Addendum No. 1

CARGO DOCKS 15 & 16 CONCRETE PAVEMENT

January 11, 2024

TYPICAL (12") CONCRETE PAVEMENT DETAIL
 NOT TO SCALE

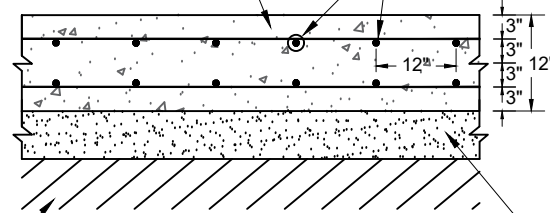
24. Could you provide a detail with the concrete paving cross section where it shows the type of rebar required?	Typical cross section attached to this Addendum No. 1.

29. Concrete is specified as 3000 psi and does not mention fibersmesh which contradicts plans cross section, which requires 5000 psi with 3lbs of fibersmesh per cy	Concrete shall be 5000 psi with 3 lbs of evenly distributed fibersmesh per CY.

7. Is reinforced concrete being used for this project?	Yes, reinforced concrete pavement is considered in all sections of this project. A double matt of #6 Rebar Gr 60 @ 12" ctrs., as specified on Sheet 8, must be used.
